# APPROVED MINUTES

## January 19, 2017 Standards Committee Meeting

RE: Minutes from the January 19, 2017 Standards Committee Meeting

## 801-TCDD-01 RURAL DETOUR (WITH MARKUPS)

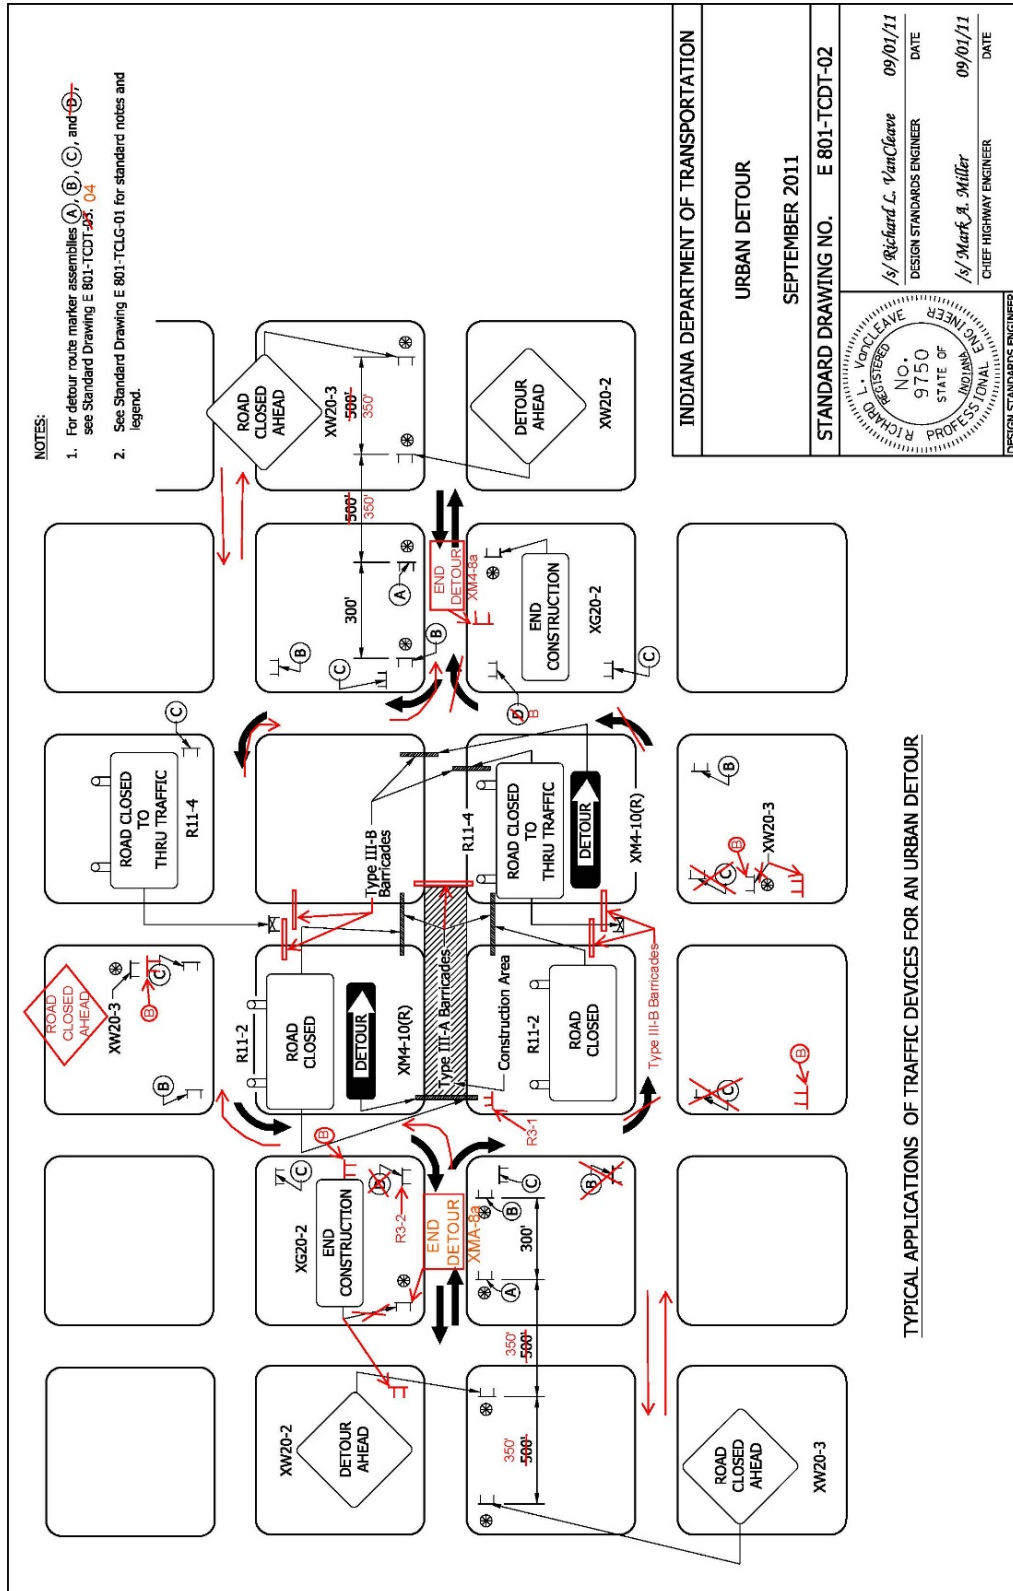
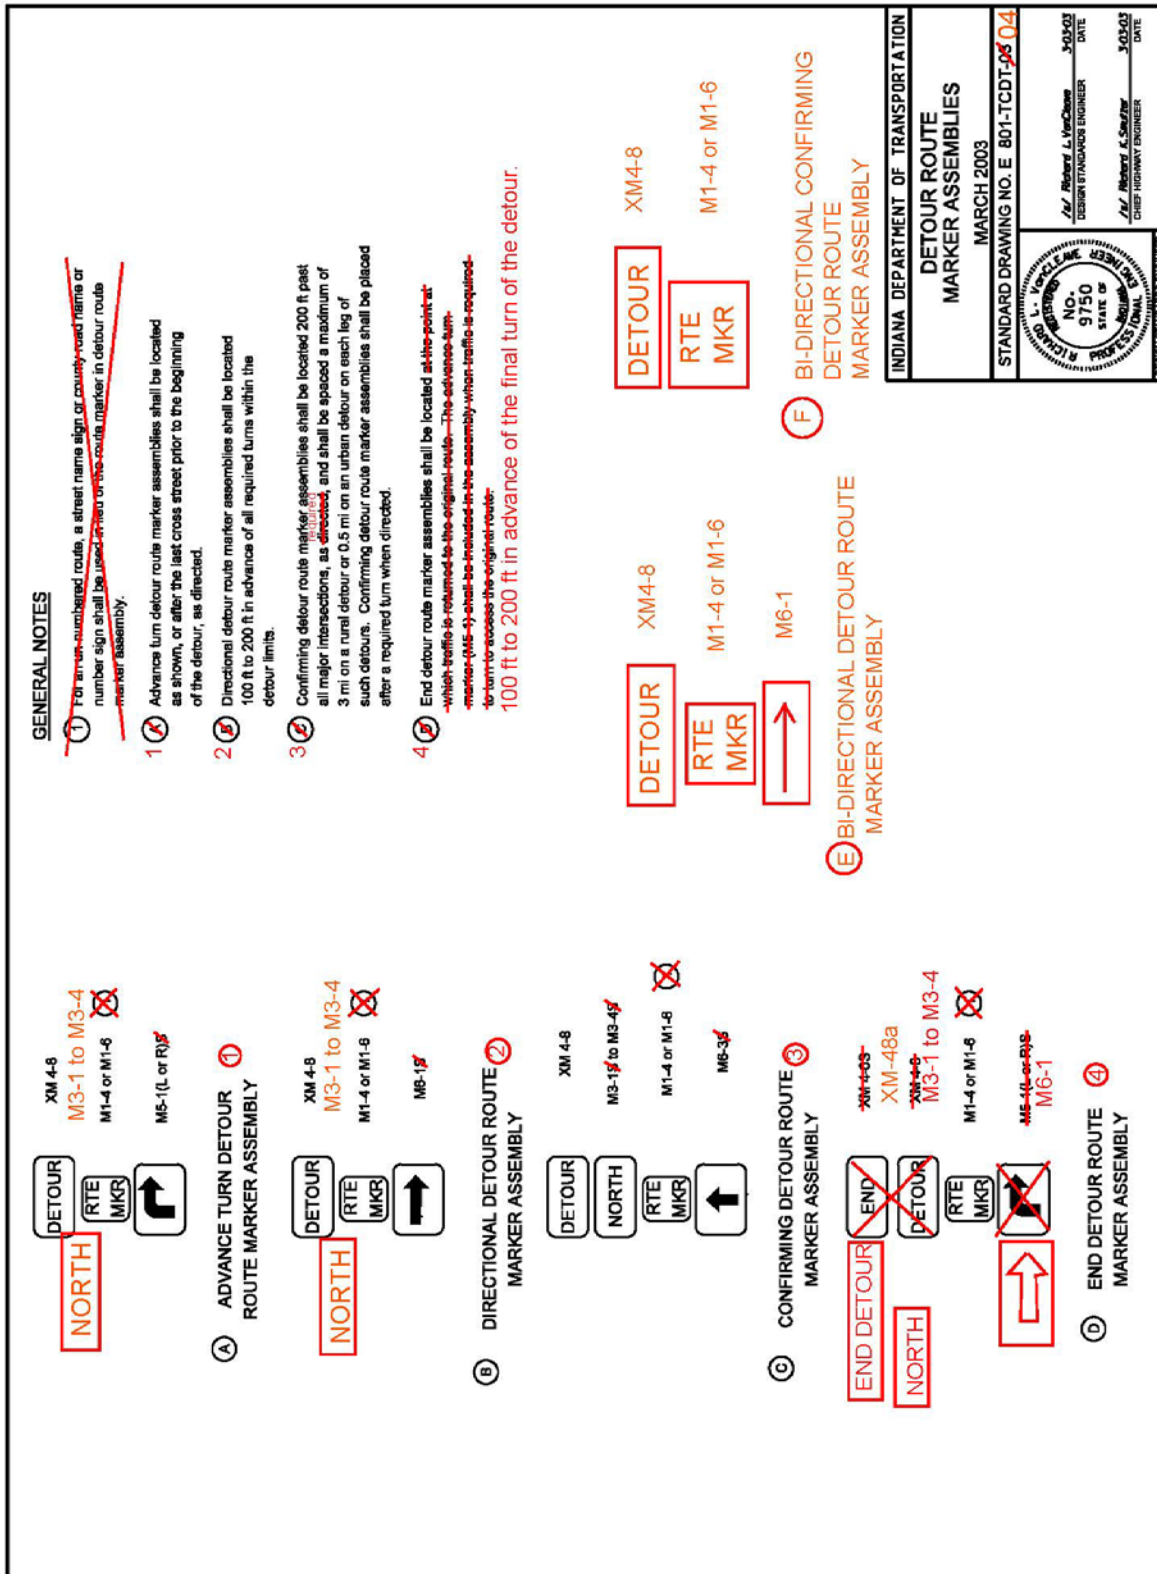
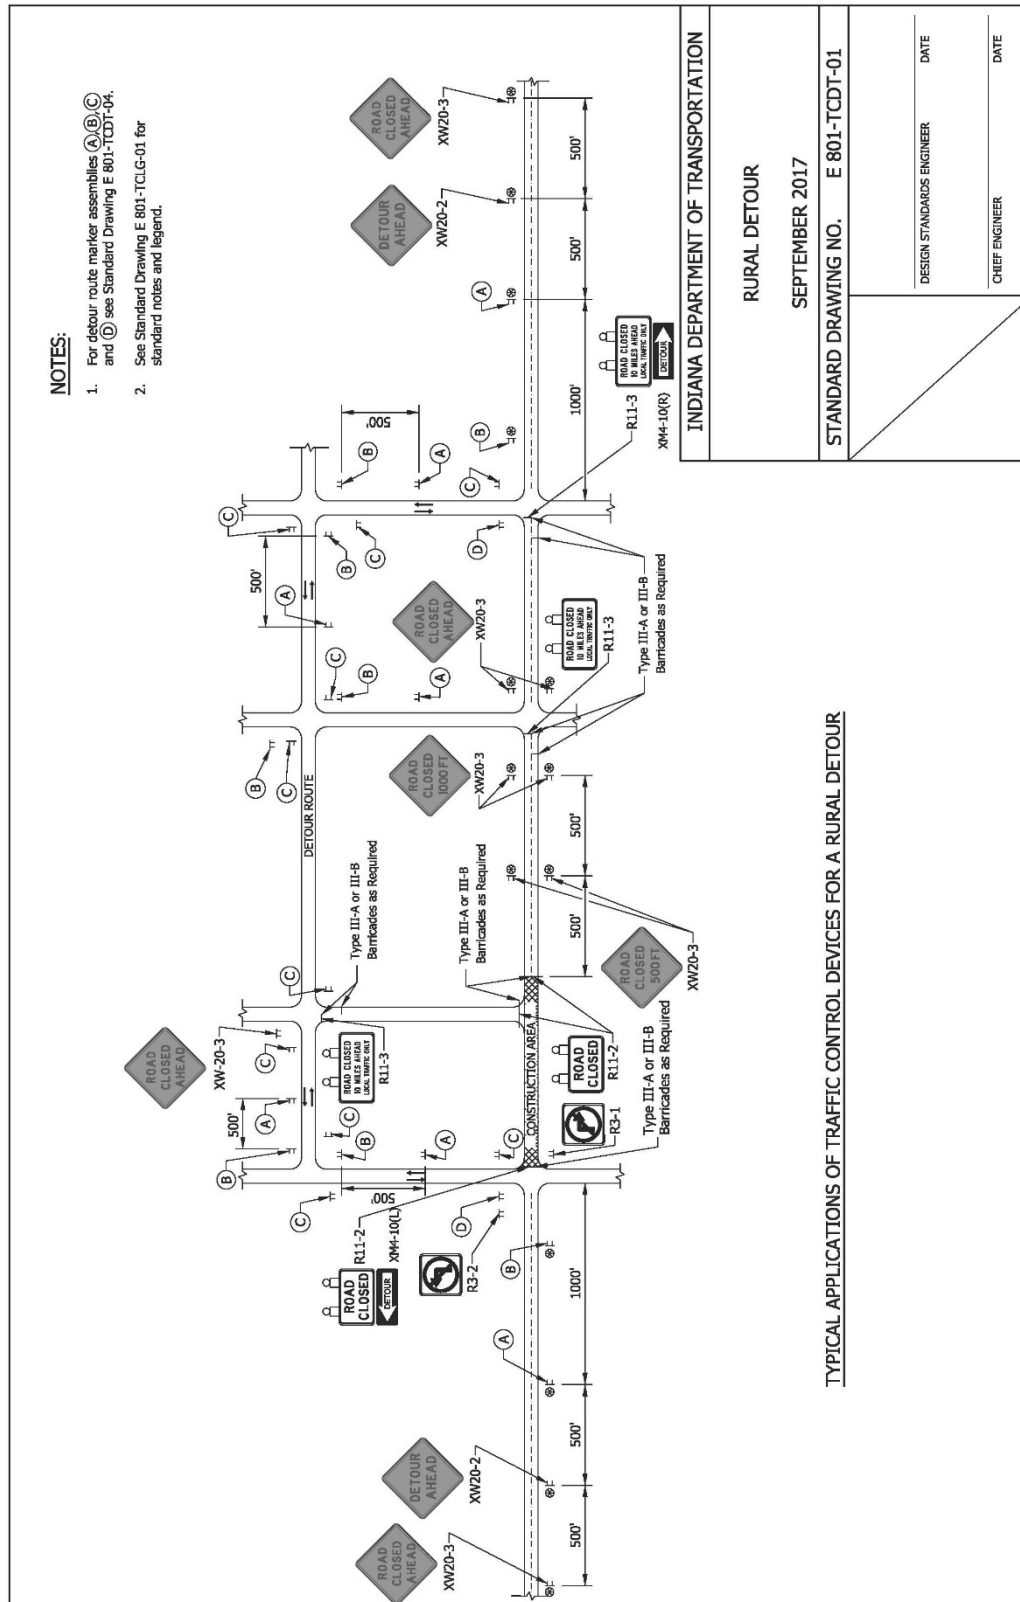
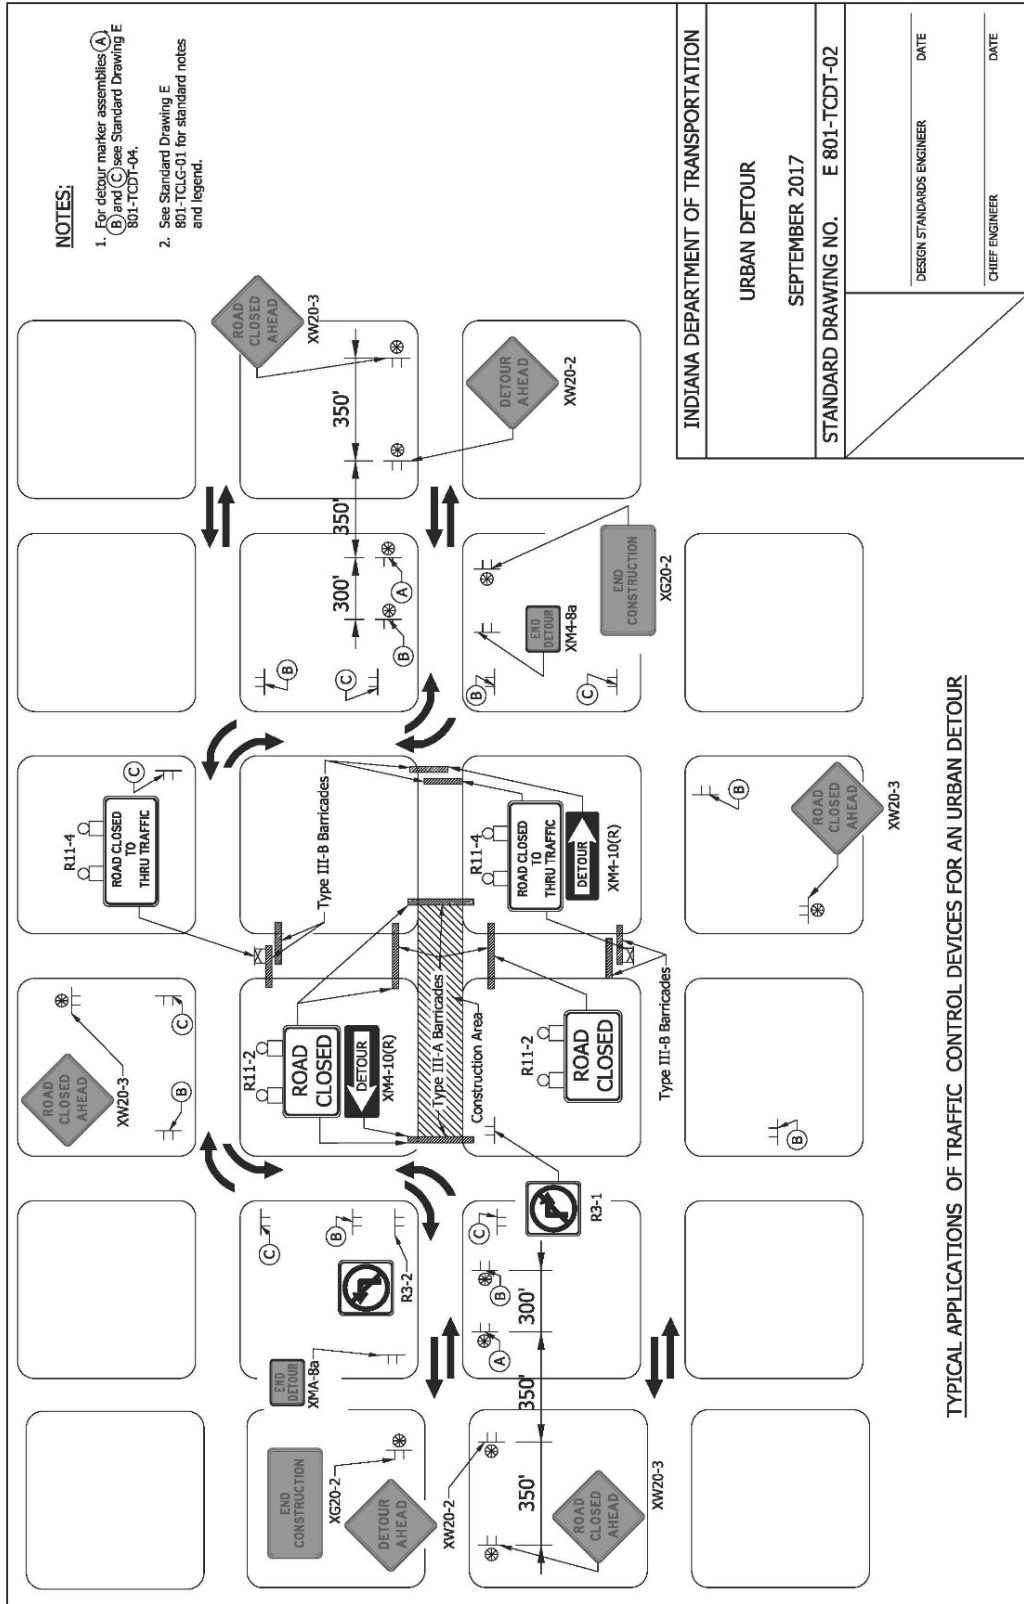
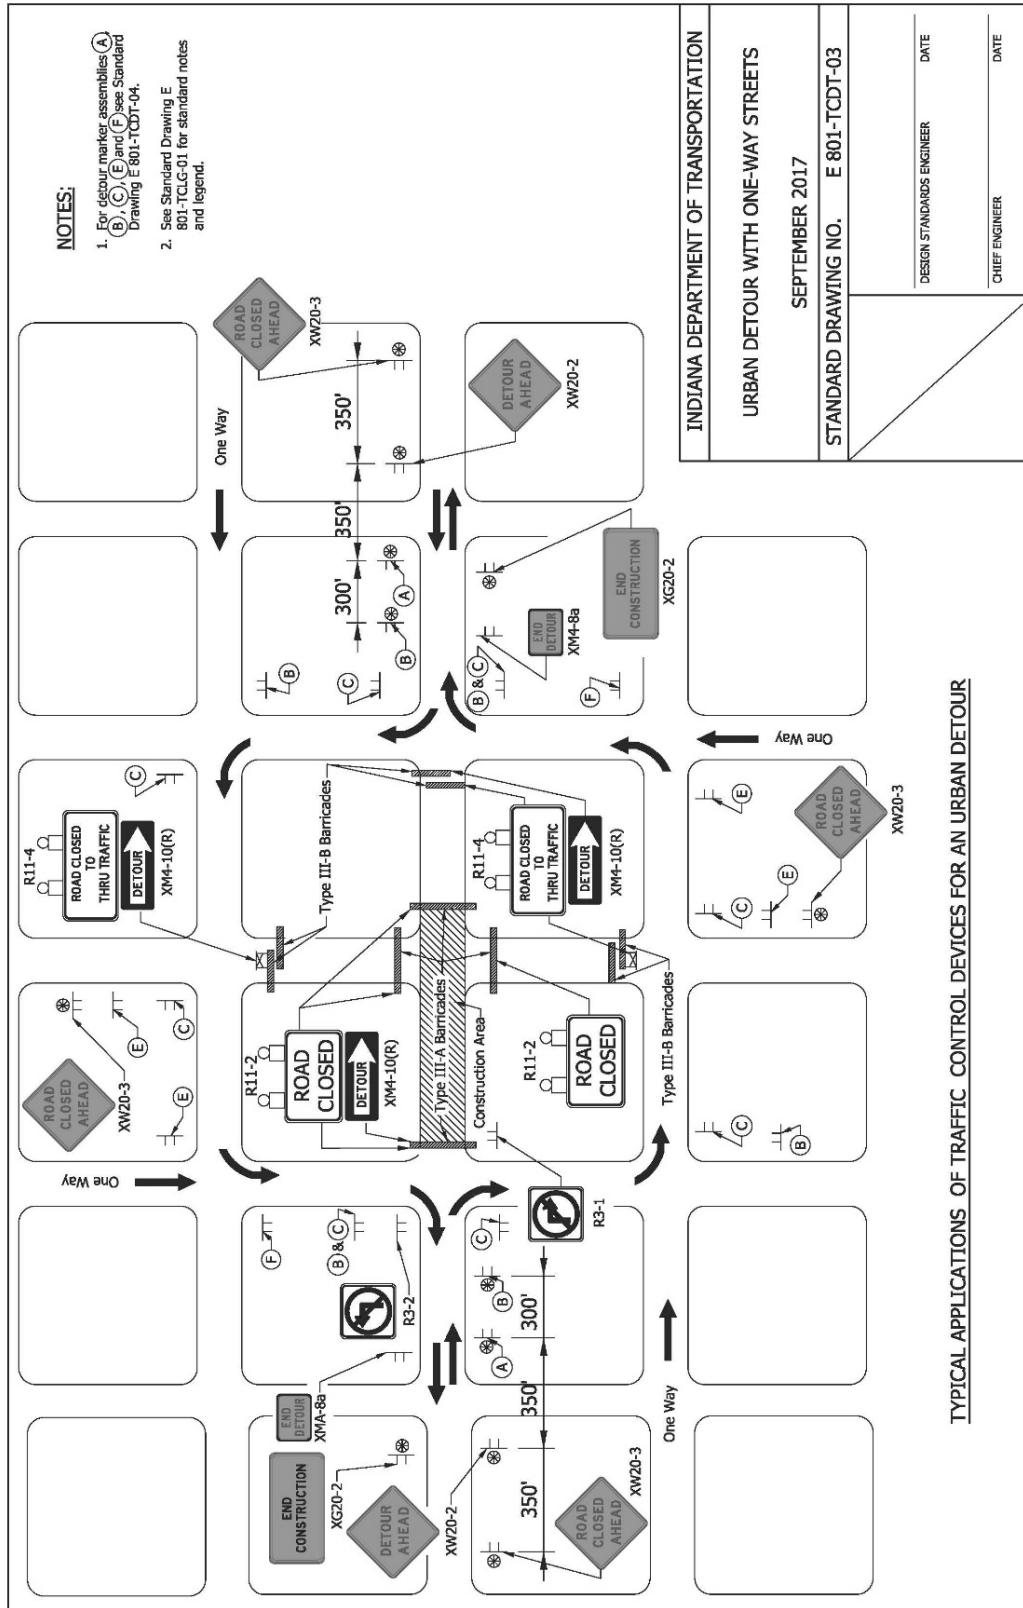
PROBLEM(S) ENCOUNTERED: The existing detour standard drawing series does not show all the signs that are needed for rural and urban detours (e.g. "Road Closed Ahead", "End Detour", etc.) nor are the barricades shown properly on some of the side street approaches. Also the current drawing for urban detours details a one-way pair scenario that could be simplified where two way traffic is maintained on the detour route.

This item was introduced and presented by Mr. Boruff who stated that the existing detour standard drawing series does not show all the signs that are needed for rural and urban detours, such as "Road Closed Ahead" and "End Detour", nor are the barricades shown properly on some of the side street approaches. Also the current drawing for urban detours details a one-way pair scenario that could be simplified where two way traffic is maintained on the detour route.

Mr. Boruff mentioned one drawing that will require revision since it shows a barricade being deleted, but the barricades should actually only be relocated. Mr. Boruff will make sure this drawing is corrected.

PROPOSED SOLUTION: Update the 801-TCDT series to show the end detour assembly and the set-up for cross streets on a two-way street urban detour.

Mr. Boruff therefore proposes that the committee approve the updated 801-TCDDT series to show the end detour assembly and the set-up for cross streets on a two-way street urban detour, as illustrated above.

807-LTHI-05 HIGHWAY ILLUMINATION TOWER DETAILS BOTTOM LATCH (WITH MARKUPS)

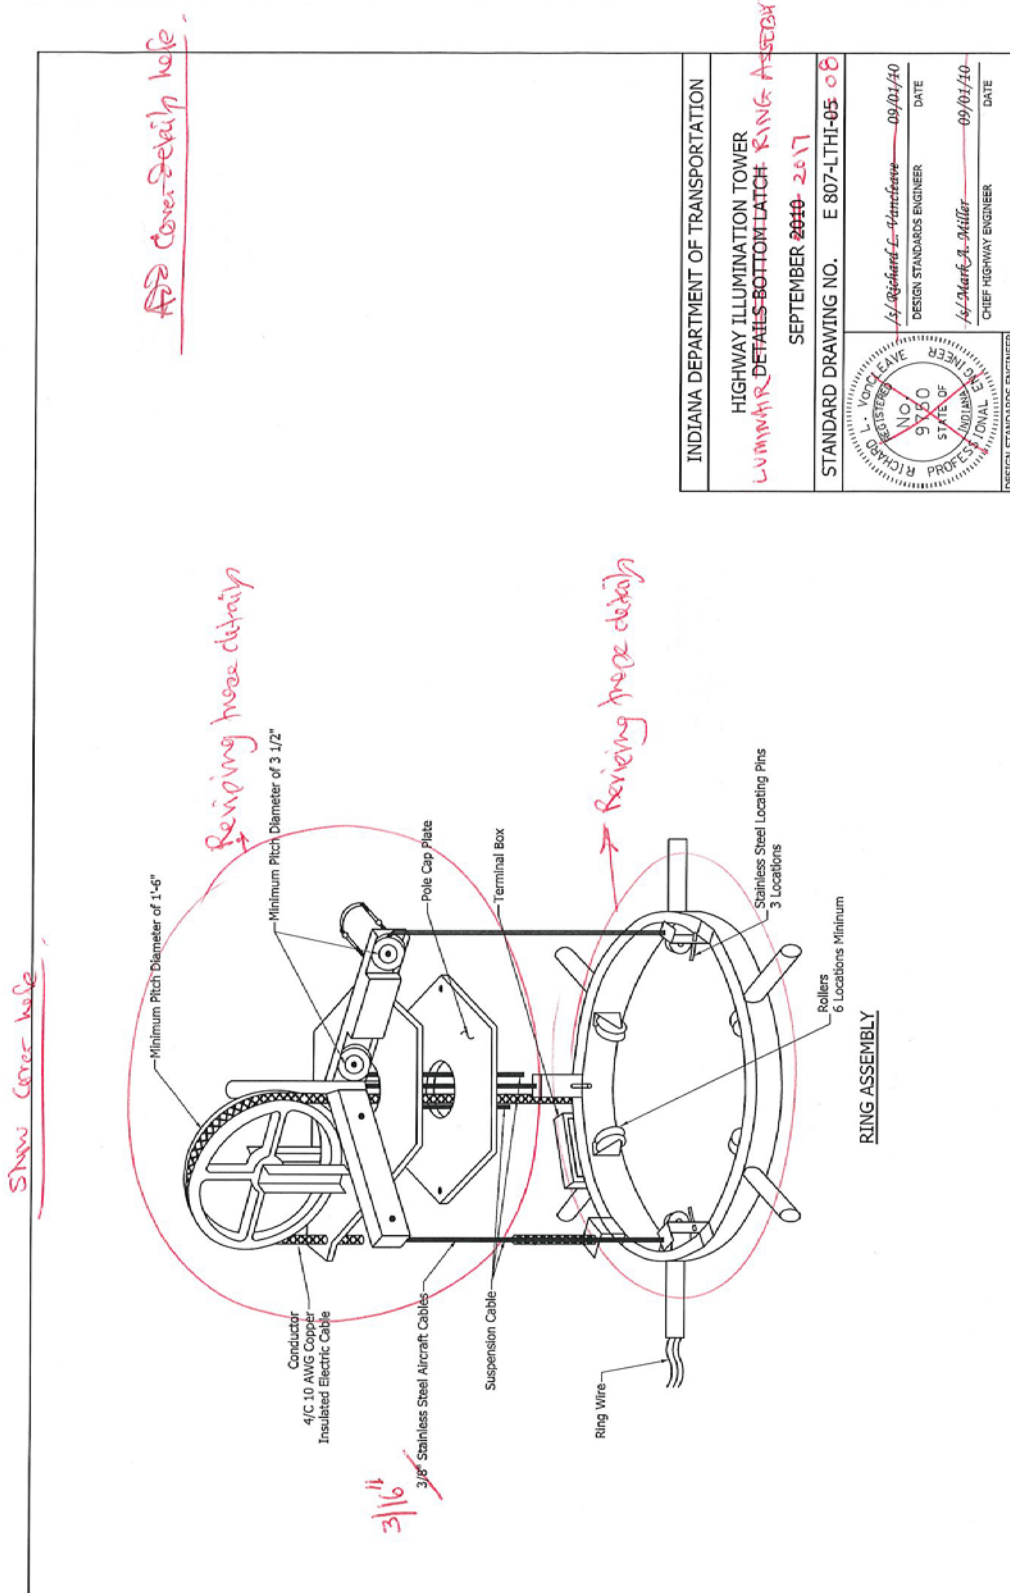
PROBLEM(S) ENCOUNTERED: The diameter (3/8") of the suspension cables for high mast tower's ring assembly shown in the current standard drawing 807-LTHI-05 is not correct per industry standards. Details of the head frame assembly are outdated. Additionally the minimum breaking strength of the suspension cables indicated in the Standard Specification is incorrect.

This item was introduced and presented by Mr. Boruff who stated that the 3/8 inch diameter of the suspension cables for high mast tower ring assemblies shown on standard drawing 807-LTHI-05 does not match current industry standards. Also, the breaking strength shown in 920.01.4 is incorrect. Mr. Boruff proposed to correct the diameter and strength of the cables as shown above. Mr. Boruff also proposed to combine standard drawings 807-LTHI, LTHM and LTPD into one series and add an option for a semi-trapezoidal retaining wall. Mr. Boruff further proposed to move standard drawings 807-LTHI-06 and 07 to the new series 807-THID drawings.
